Access Compliance Report

Public Rights-of-Way

(Curb Ramps)

Intersection ID: 4660	Main Street: ELDERBANK_DR	Cross Street: TRINITY_RD	Location:	N
ADA ID: 88124751821B	Ramp Type: Perp	Initial Pass/Fail: Fail	Overall Compliance: No	Severity Score: 12.5
Codes/Mitigation Info/Possible Solution		Field Measurements/Component Compliance

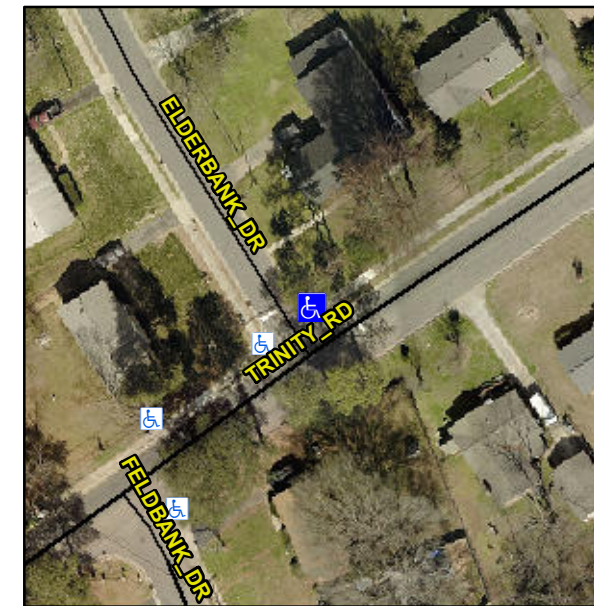
Compliance	Description	Data	Compliance	Description	Data
N/A	Ramp Length (in)	63.0	No	Ramp Slope (%)	8.7
Yes	Ramp Width (in)	51.0	Yes	Ramp XSlope (%)	1.0
N/A	Flare Type LT	N/A	N/A	Flare Type RT	N/A
N/A	Flare Slope LT (%)	N/A	N/A	Flare Slope RT (%)	N/A
N/A	Flare Traversable LT?	N/A	N/A	Flare Traversable RT?	N/A
N/A	Landing Length (in)	N/A	N/A	DWS Provided?	N/A
N/A	Landing Width (in)	N/A	N/A	DWS Contrast?	N/A
N/A	Landing Slope (%)	N/A	N/A	DWS Length (in)	N/A
N/A	Landing X Slope (%)	N/A	N/A	DWS Full Width?	N/A
N/A	Landing Curb? (Y/N)	N/A	N/A	DWS Offset (in)	N/A
N/A	Shared Landing?	N/A			
N/A	Gutter Ponding?	N/A	N/A	Gutter Slope (%)	N/A
N/A	Gutter Lip Ht (in)	1.0	N/A	Gutter X Slope (%)	N/A
N/A	Painted X Walk1?	No	N/A	Painted X Walk2?	N/A
	X Walk 1 Direction	To W		X Walk 2 Direction	N/A
N/A	X Walk 1 Width (in)	N/A	N/A	X Walk 2 Width (in)	N/A
	X Walk 1 Slope (%)	0.6		X Walk 2 Slope (%)	N/A
	X Walk 1 X Slope (%)	1.2		X Walk 2 X Slope (%)	N/A

Remove & Replace Entire Ramp.
